Rosefield Solar Farm

Chapter 13: Noise and Vibration Figures

APFP Regulation Reg 5(2)(a)
Planning Act 2008
Infrastructure Planning
(Applications: Prescribed Forms
and Procedure) Regulations 2009
EN010158/APP/6.3.5
Revision 5
Change Application
June 2026
Rosefield Energyfarm Limited

TITLE: FIGURE 13.3 OPERATIONAL
 PHASE NOISE CONTOURS
 (WITHOUT ADDITIONAL MITIGATION)

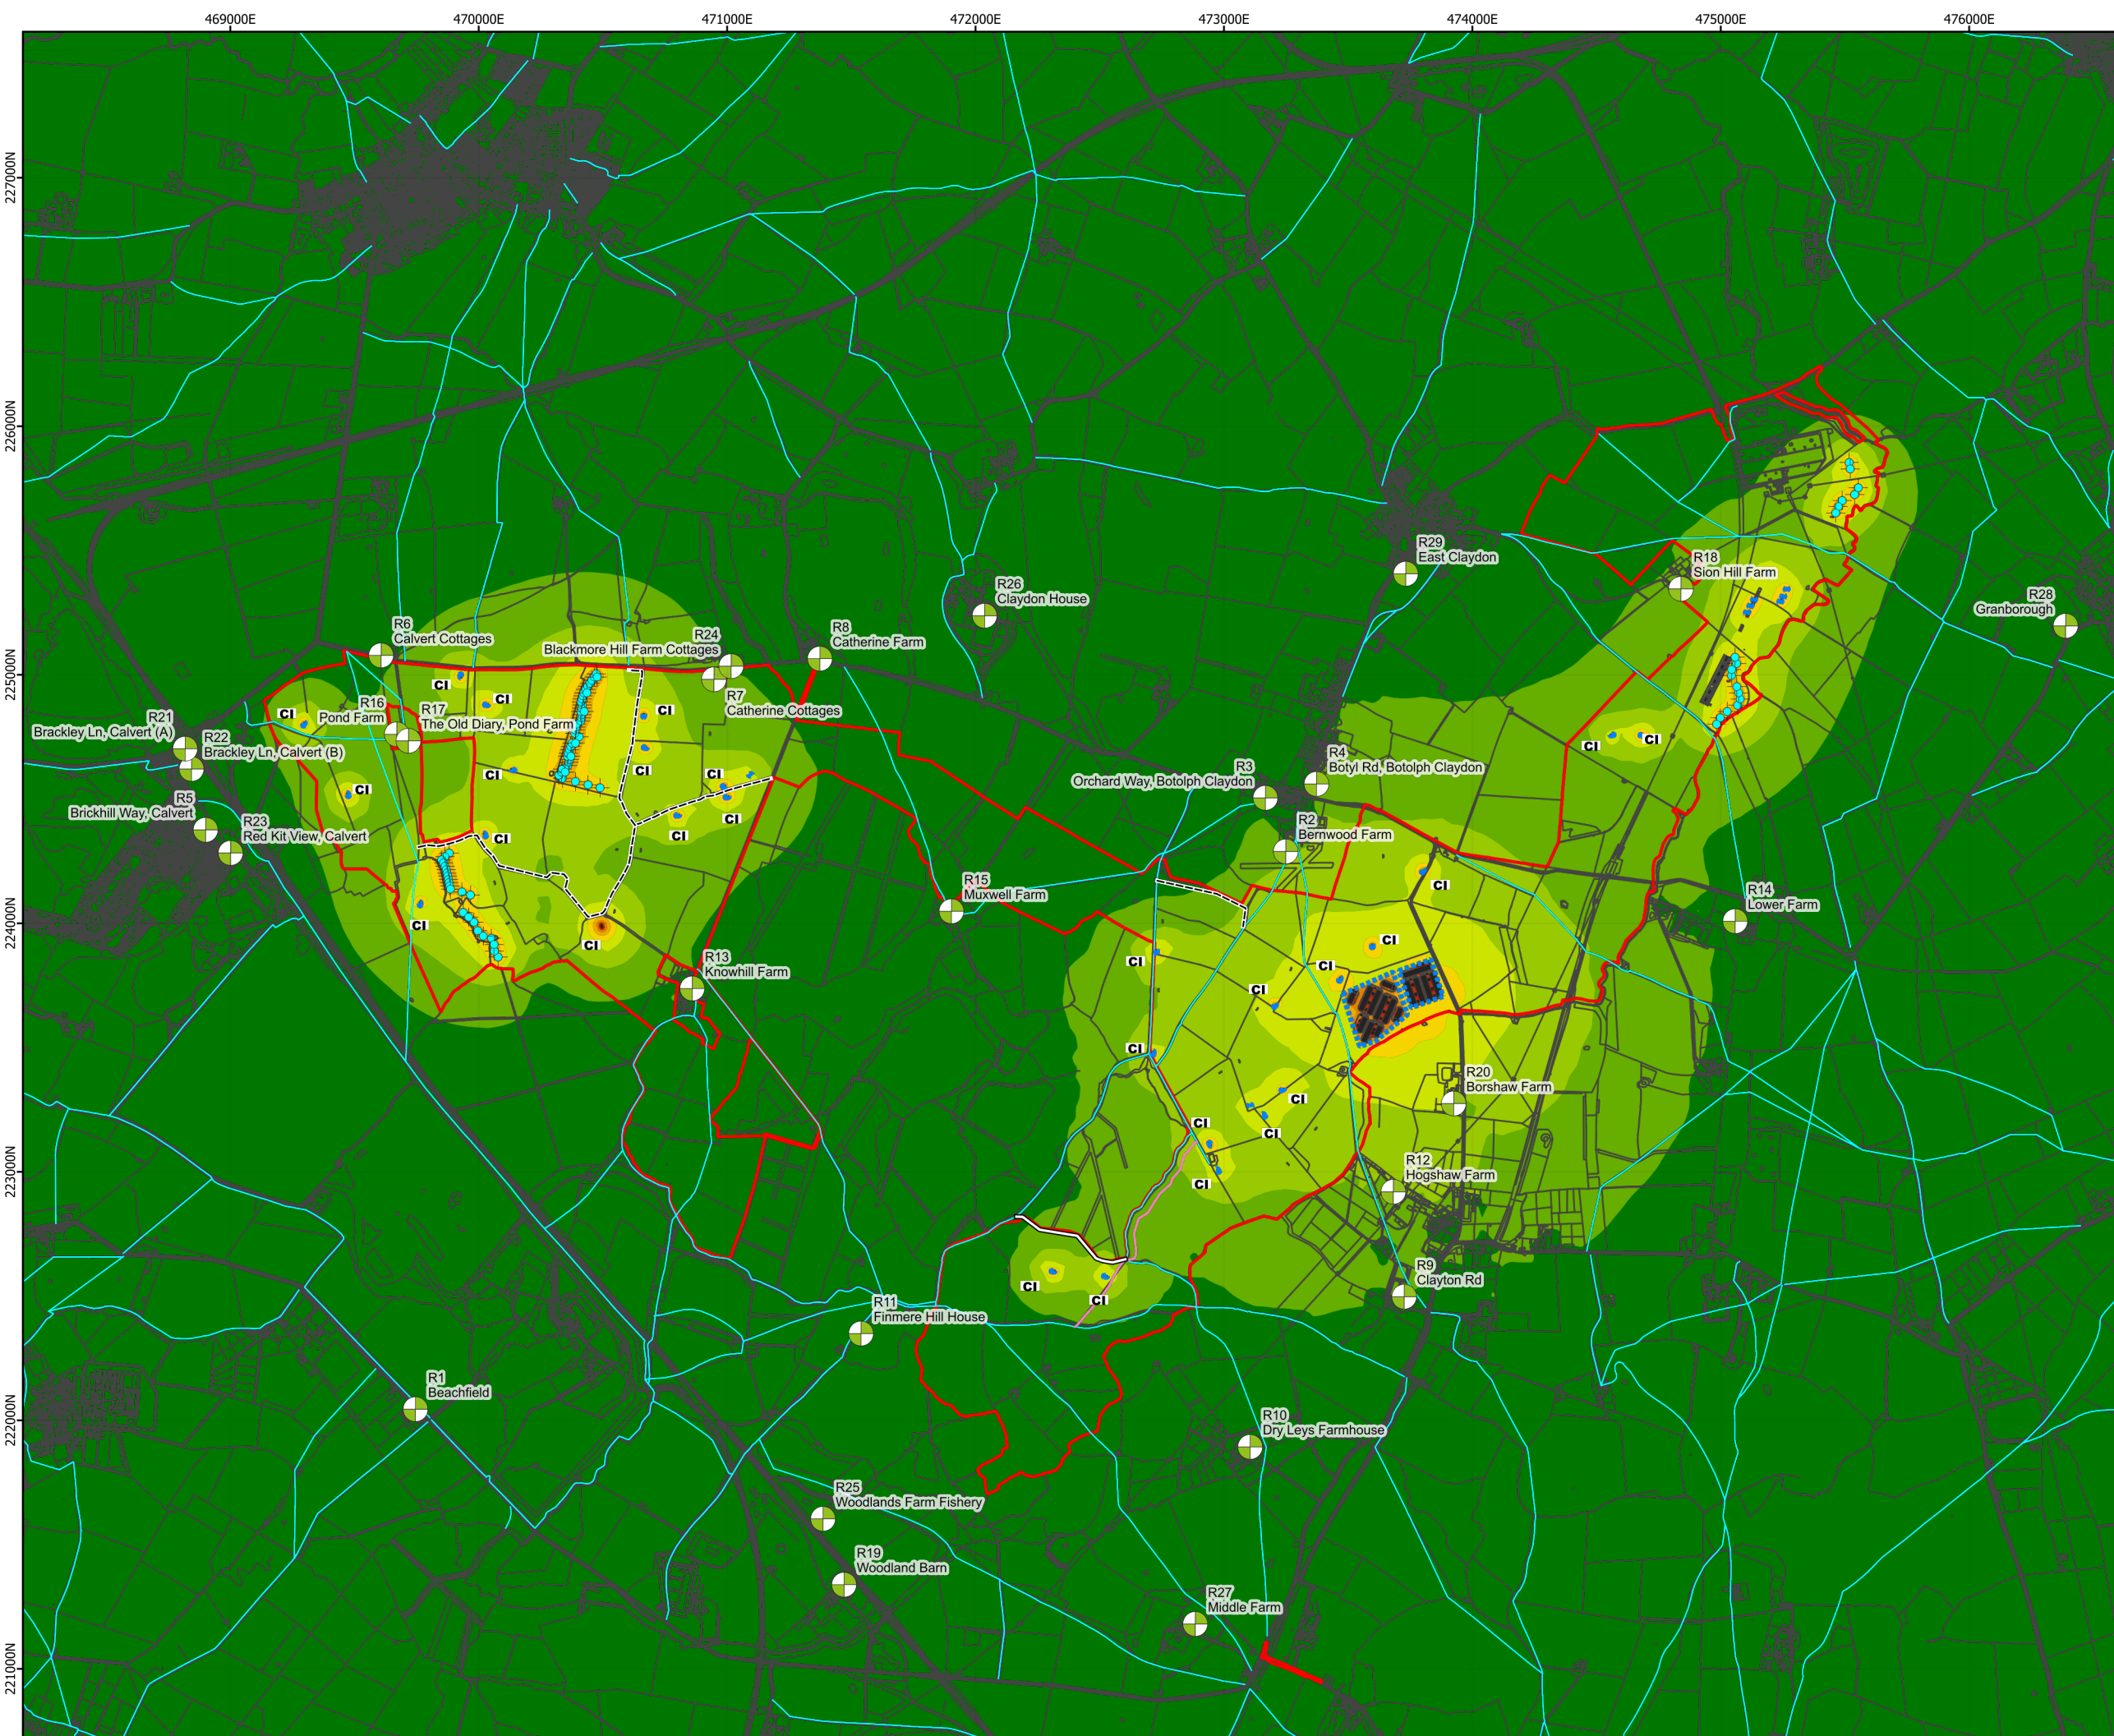
Drawing number	Revision number	Drawing title	Scale	Reason for revision
13.1	02	Study Area and Receptors	1:30,000 @ A3	No change made
13.2	01	Baseline Survey Locations	1:30,000 @ A3	No change made
13.3	04	Operational Phase Noise Contours (without additional mitigation)	1:25,000 @ A3	Updated to include the proposed bridleway link
13.4	04	Operational Phase Noise Contours (with additional mitigation)	1:25,000 @ A3	Updated to include the proposed bridleway link
